**AGENDA
TECHNICAL REVIEW COMMITTEE
REGULAR MEETING
JUNE 25, 2026
10:00 AM
CITY HALL COMMISSION CHAMBERS
204 ASH STREET
FERNANDINA BEACH, FL 32034**

Tom Miller
1750 South 14th Street Partners LLC
5047 First Coast Hwy
Fernandina Beach, FL 32034

Applicant Name: Tom Miller
Project Description: South 14th St Flex Spaces
Location: 1740 South 14th Street
PIN(s): 00-00-31-127A-0002-0000
TRC Case Number: **TRC 2025-0010**

REVIEW COMMENTS:

CONTENT: SITE PLAN

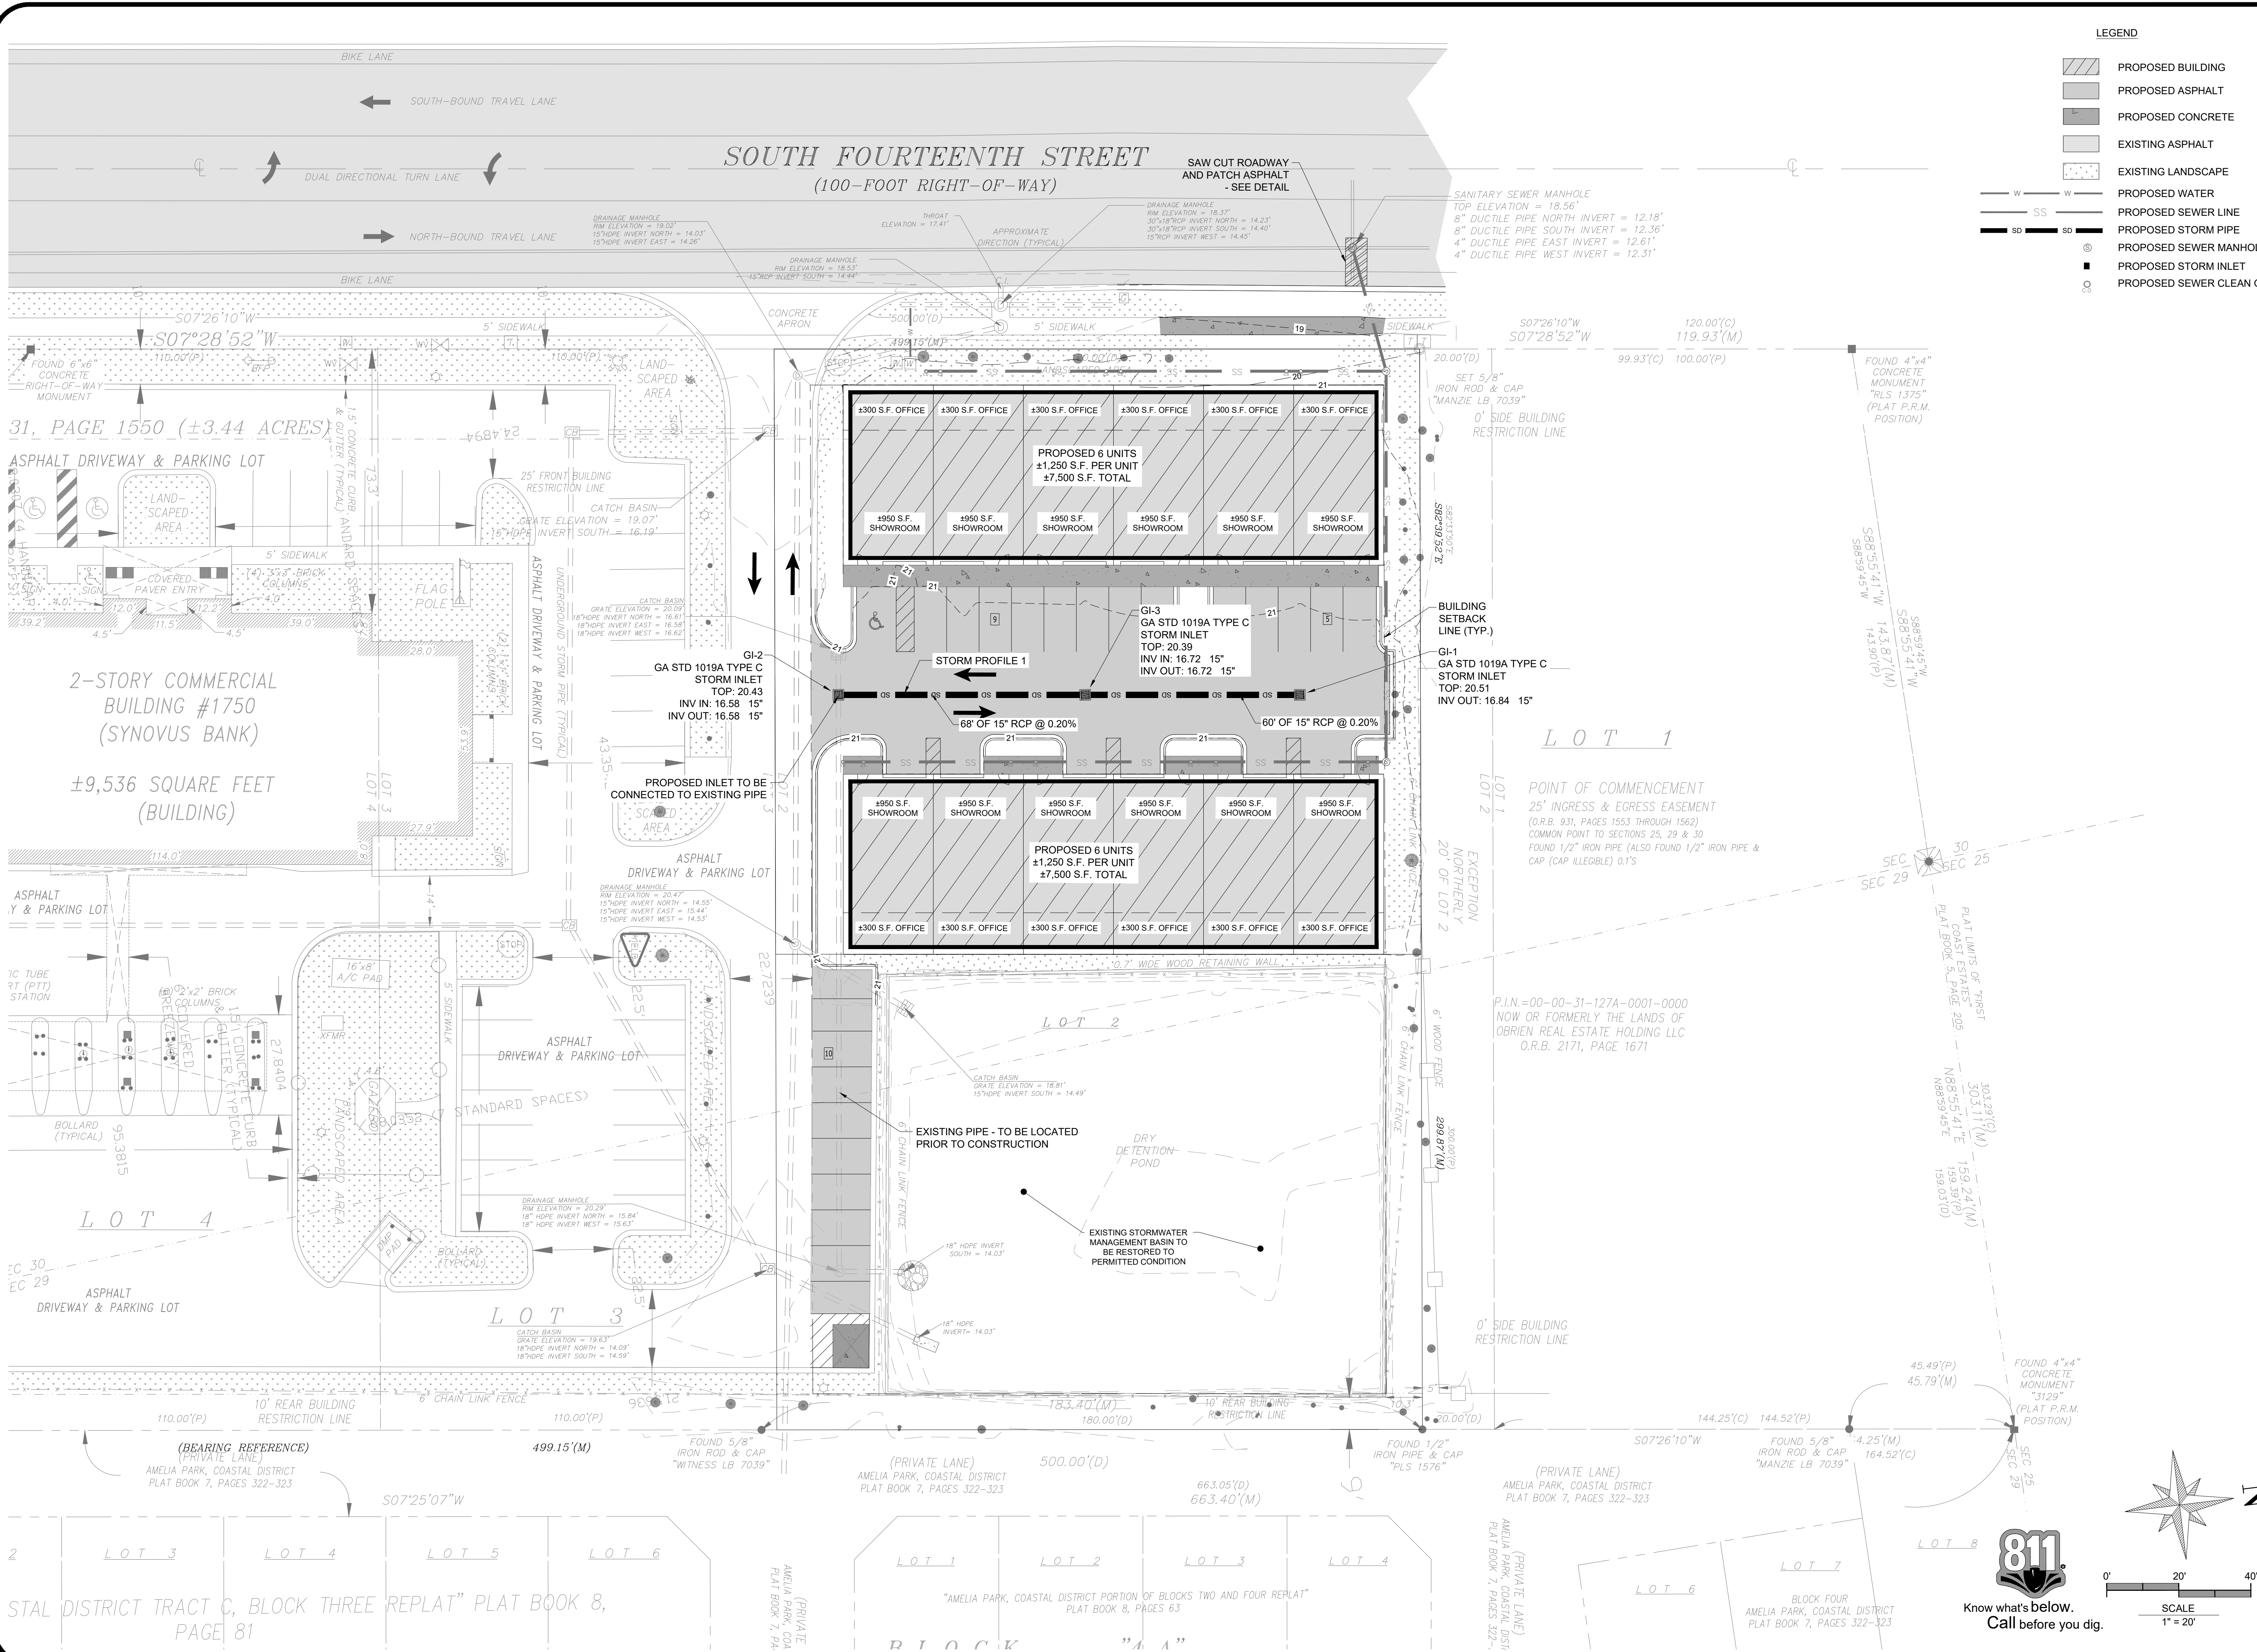
Dumpster location is appropriate. Crosswalks/pavers across the garage door openings on the east building to connect the sidewalk and facilitate pedestrian circulation is required. Pedestrian connection to the easterly parking area is required. Pedestrian sidewalk to parking spaces to the east. Please provide bike racks per LDC Table 7.01.03(E).

Proposed dumpster location is acceptable; however, please confirm the dumpster area will be fully enclosed with a solid masonry wall, vinyl or wooden fence per section 5.01.07.

CONTENT:
LANDSCAPE PLAN

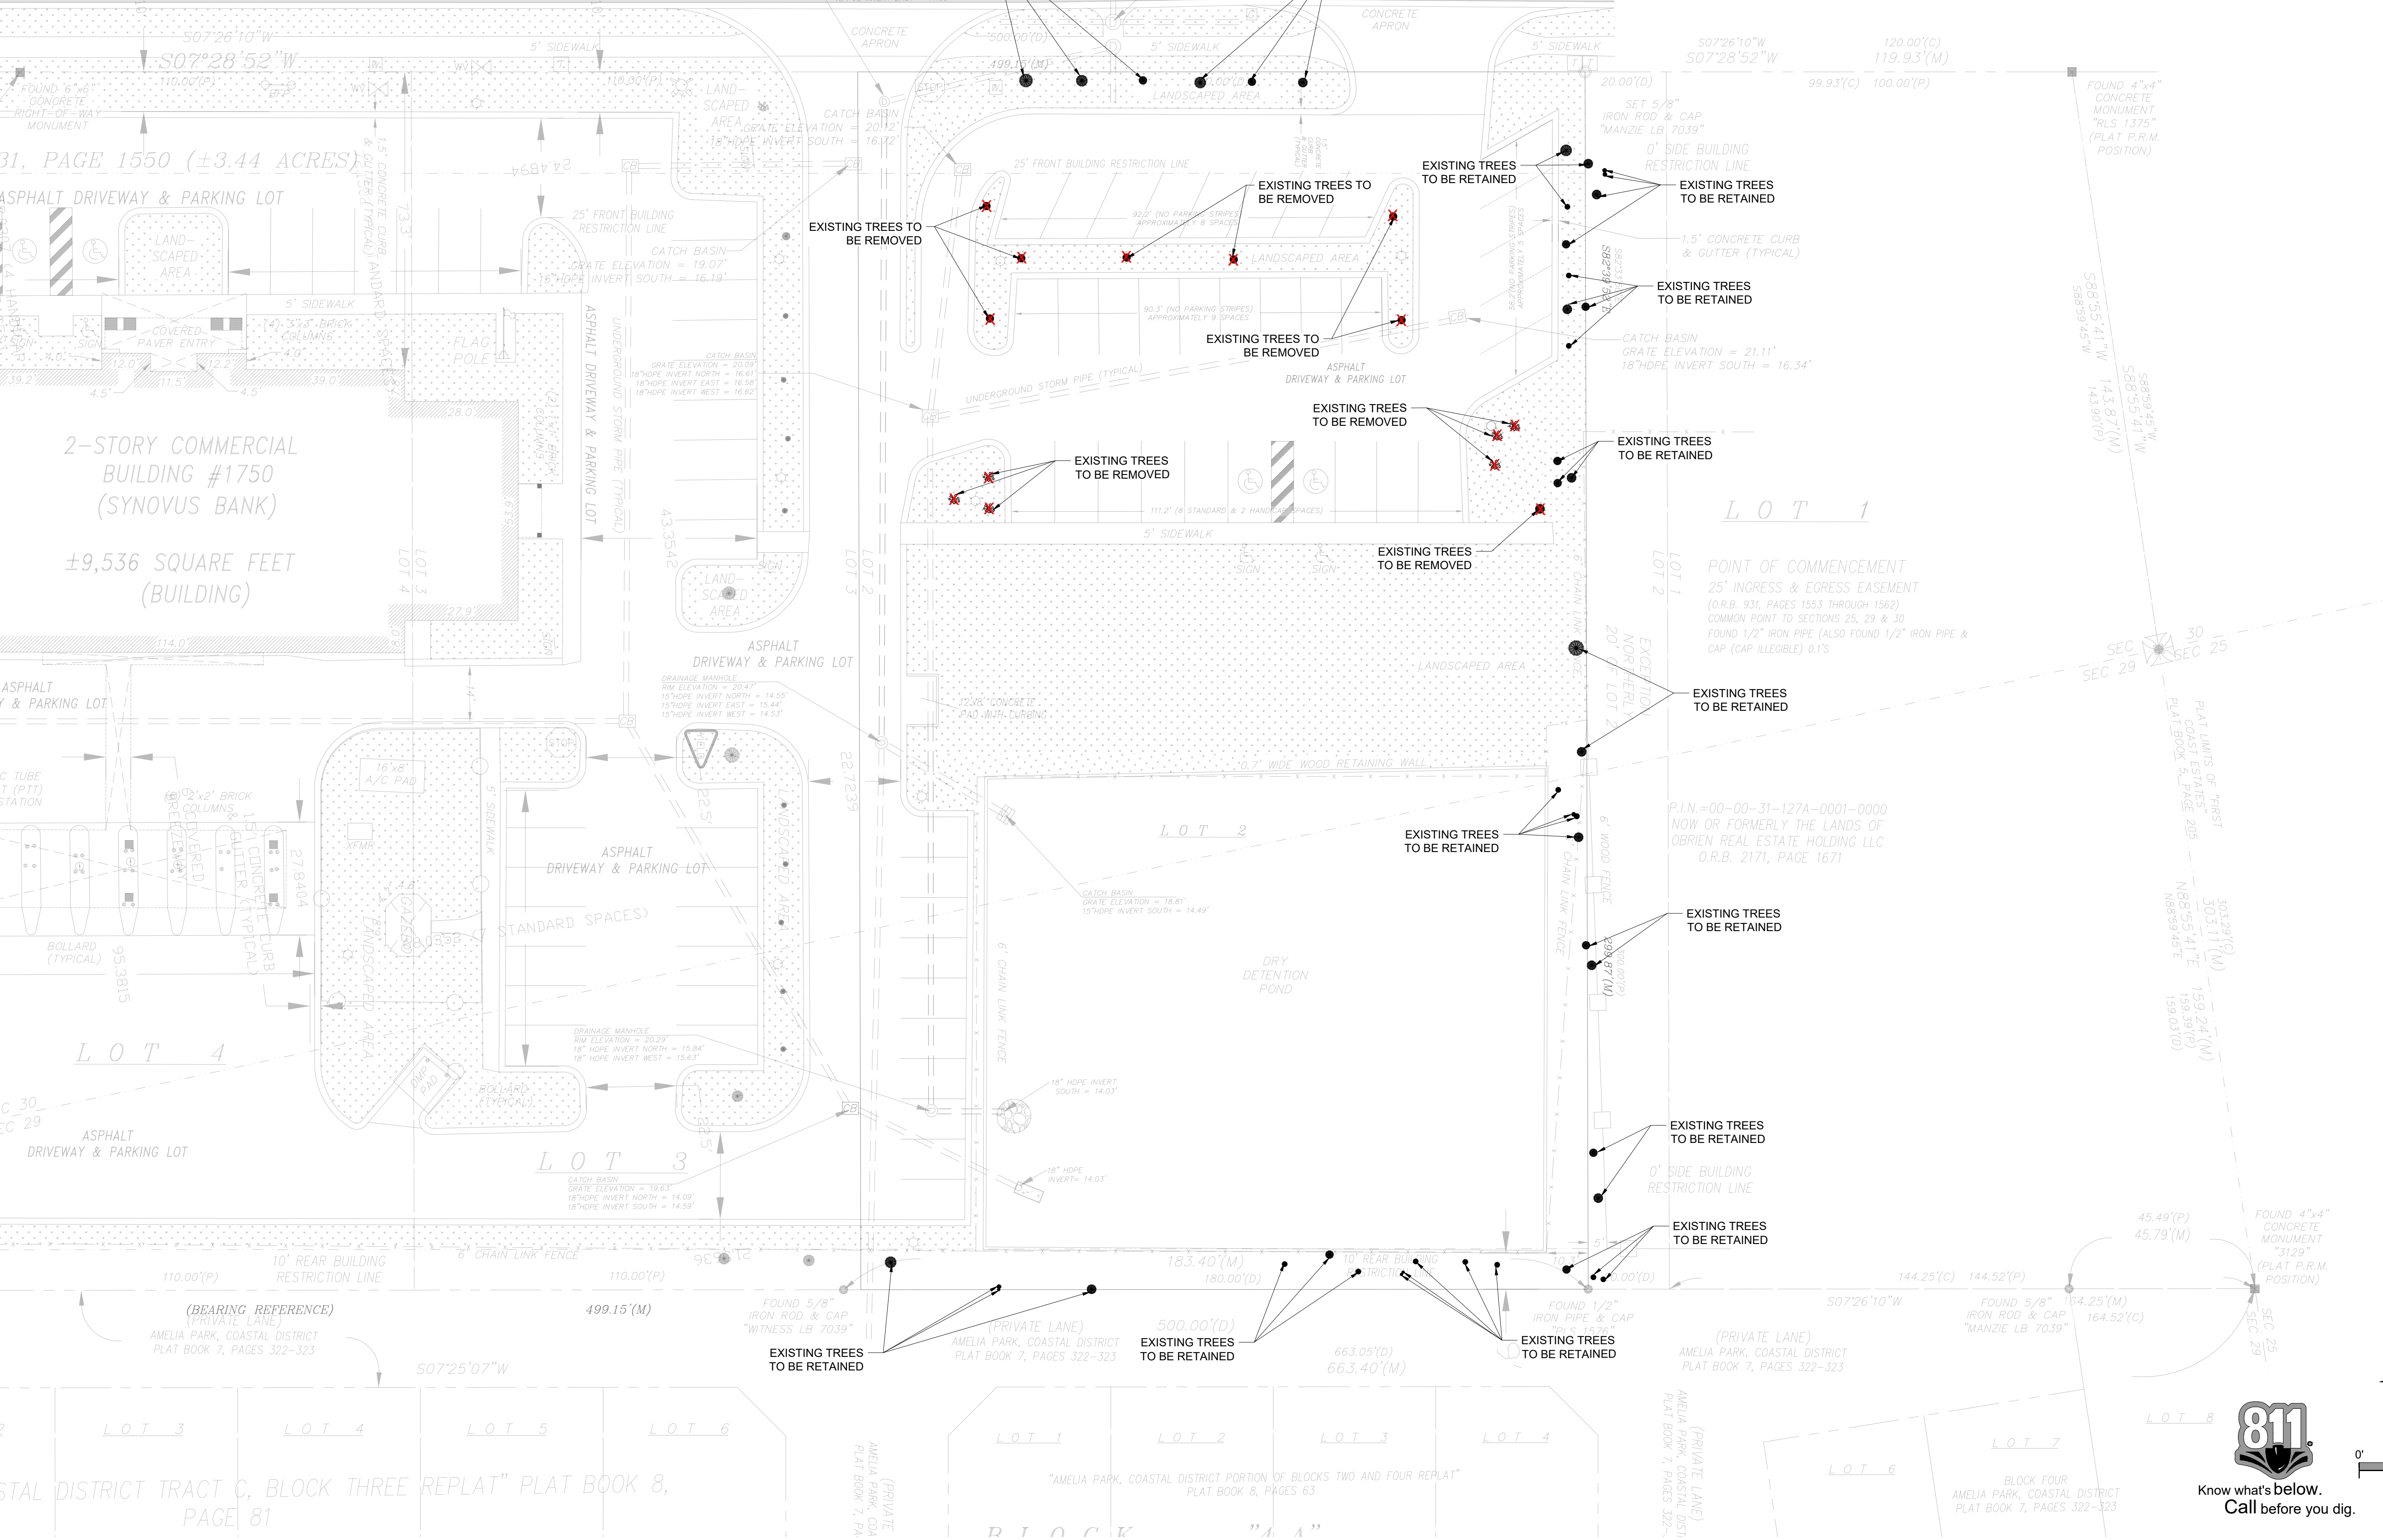
This project requires 40 Native Shade Trees. Page 11 shows 38 trees will be retained (short 2 native shade trees if retained trees are native shade trees per definition). Please submit a tree survey showing the species of these retained trees. Landscape parking breaks require a tree planting per LDC 4.05.07, please submit a landscape plan showing landscaped parking landscape breaks. Will trees around detention pond in rear be retained? Landscape plan needs to show buffer type C on east side. dn 6/9/26

INSIDE DROP - SEWER MANHOLE
NTS

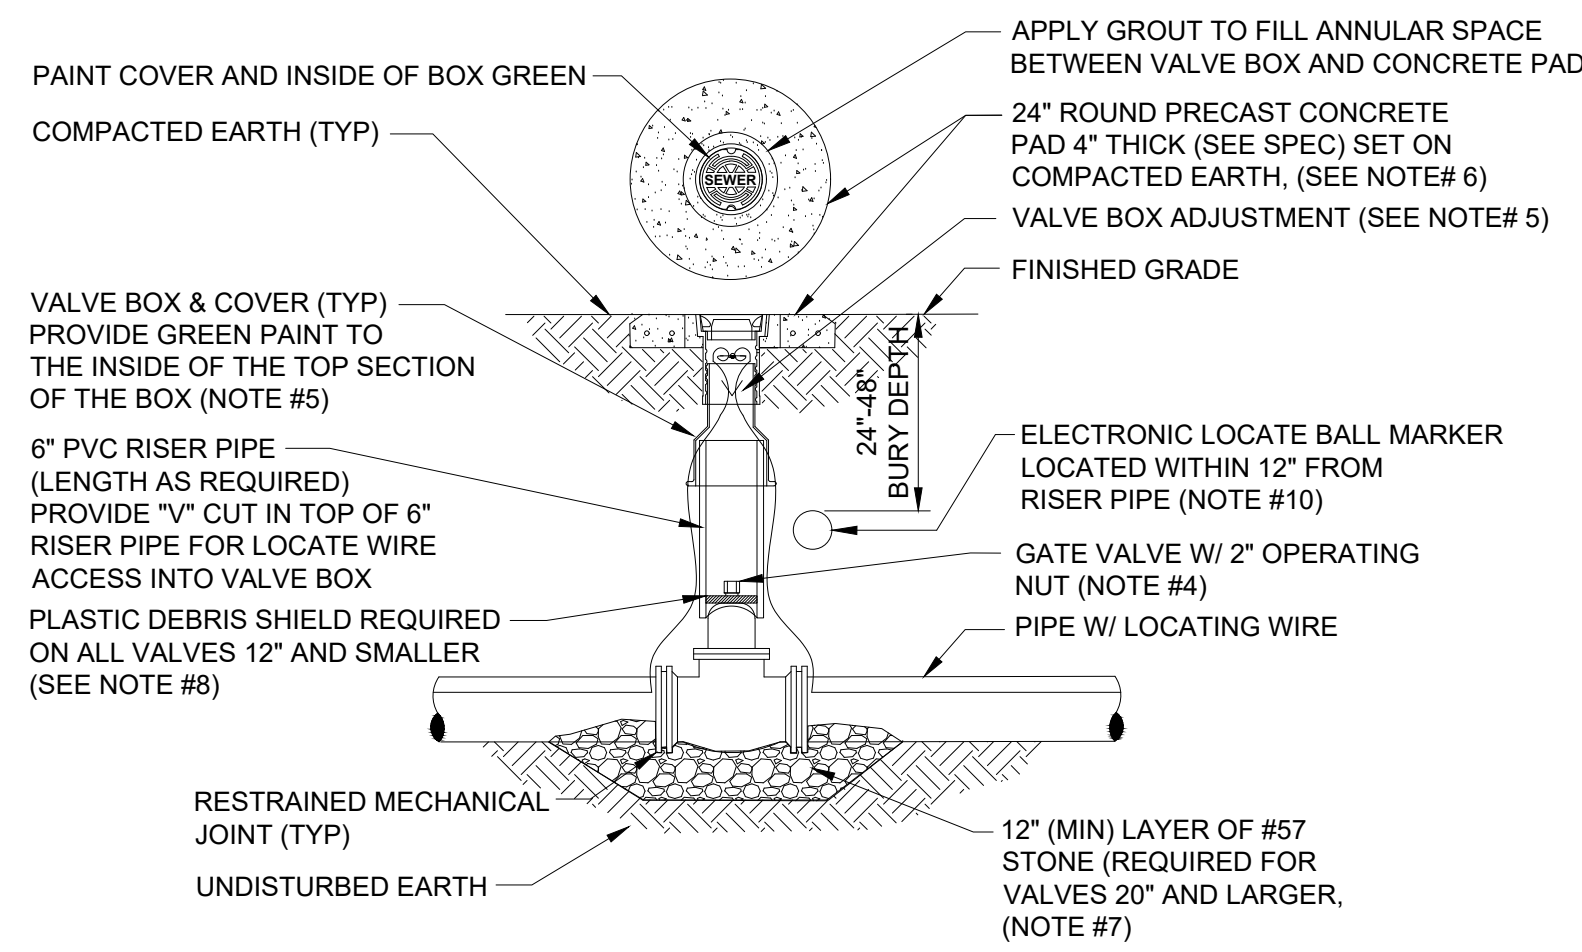
- Please show details about the individual sewer services.
- Inside drop at manhole shows a plug at the end of the tee but should be a 1/2 plug or replace the tee with a bowl system.
- Add detail showing method for coating the manhole after inside drop installation.
- Please provide evidence the existing retention will sufficiently support the project with a formal letter from SJRWMD or a stormwater drainage report. Please provide evidence the existing retention will sufficiently support the project with a formal letter from SJRWMD or with a stormwater drainage report.
